RESOLUTION SETTING HEARING ON REQUEST FROM EASTGATE PLAZA, LLC AND NET LEASE DEVELOPMENT, LLC FOR THE 6TH AMENDMENT TO THE EASTGATE PLAZA PUD CONCEPTUAL PLAN FOR PROPERTY LOCATED IN THE VICINITY OF 1500 EAST EUCLID AVENUE

Communication from the City Plan and Zoning Commission advising that at their September 2, 2021 meeting, the following action was taken regarding a request from Eastgate Plaza, LLC (owner), represented by Norman Weinstein (officer) and Net Lease Development, LLC (purchaser), represented by Mark Huonder (officer), for review and approval of a 6th amendment to the Eastgate Plaza PUD Conceptual Plan on property located in the vicinity of 1500 East Euclid Avenue, to allow development of a 2.09-acre parcel with a restaurant building with a drive-up window and a multiple-tenant commercial building.

EASTGATE PUD CONCEPTUAL PLAN

1450 EAST EUCLID AVENUE

1 MAIN ENTRANCE ELEVATION
SCALE: 1/4" = 1'-0"

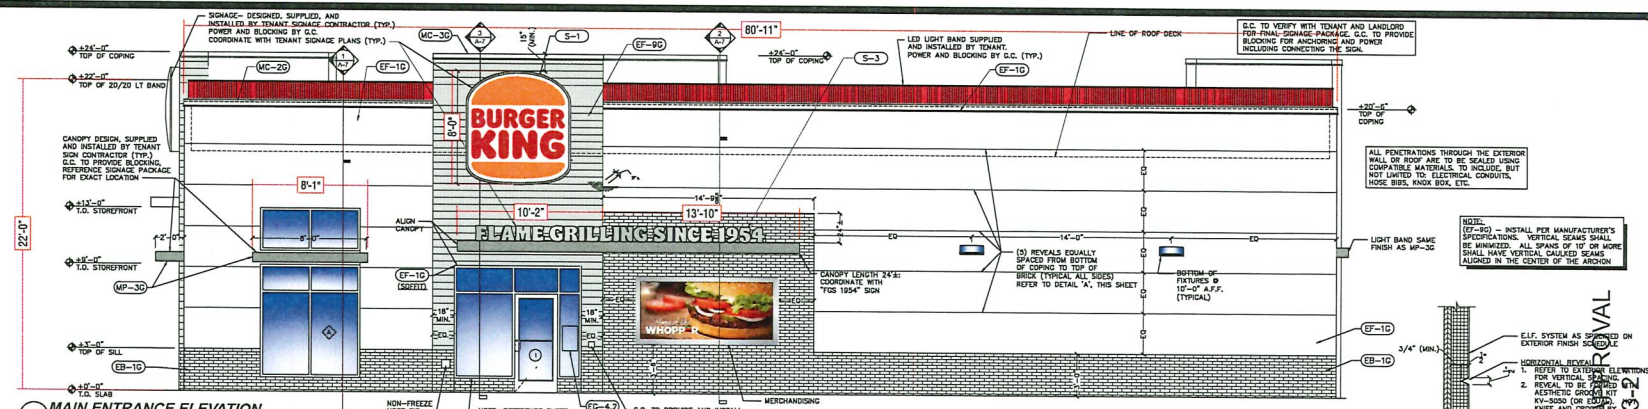
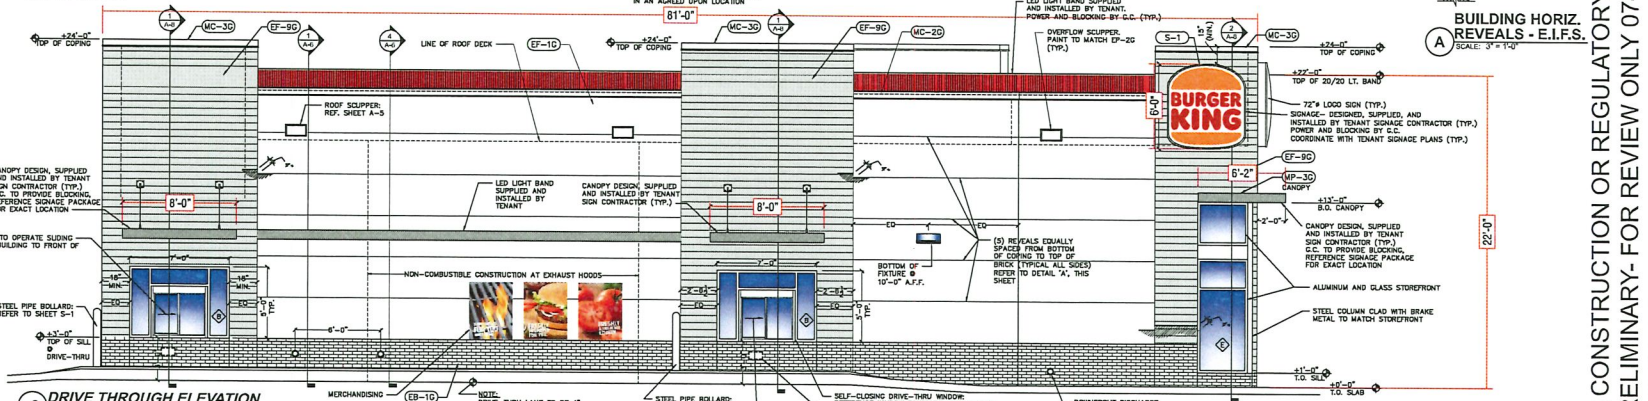
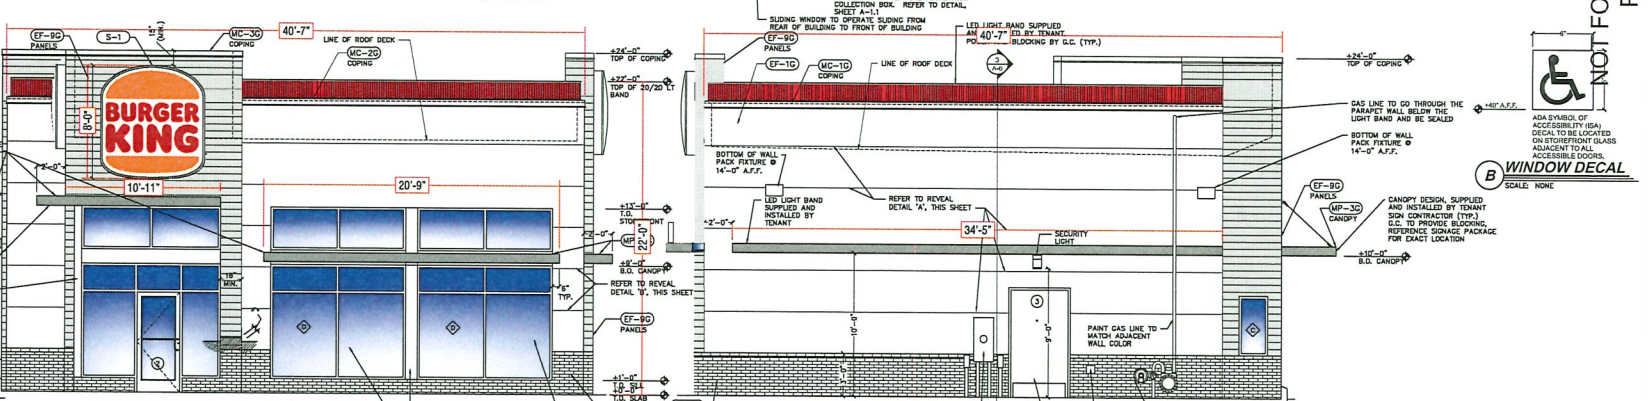
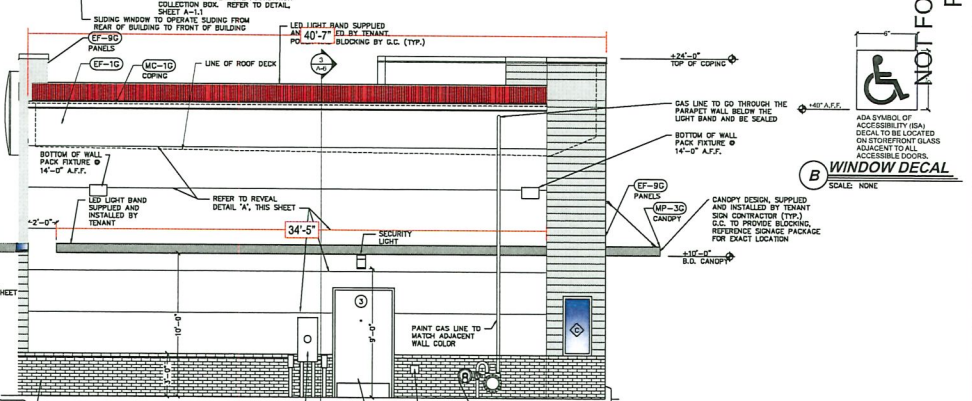
- 6. Urban Design:** The proposed “PUD” Conceptual Plan demonstrates that the proposed fast-food restaurant building would be constructed to blend with the current surrounding building materials. It indicates that the building would be sided with a combination of stucco system, facebrick, and fiber cement panels.

Staff recommends that all stucco shown on the building elevations shall meet the standards necessary in order to be considered as a “Major Façade Material” prohibiting EIFS materials, as regulated in City Code Chapter 135 and that all brick shown on the building elevations shall be full-dimensional brick and not thin brick.

- 9) Provision of a note that states that all stucco shown on the building elevations shall meet the standards necessary in order to be considered as a "Major Façade Material" prohibiting EIFS materials, as regulated in City Code Chapter 135.

- 10) Provision of a note that states that all brick shown on the building elevations shall be full-dimensional brick and not thin brick.
- 11) Provision of a note that states that all mechanical equipment, roof top units, condensers, meters, transformers or other such equipment shall be provided, including the undergrounding of all overhead utilities whenever reasonably practicable, in accordance with Chapter 135: Planning and Design Code.
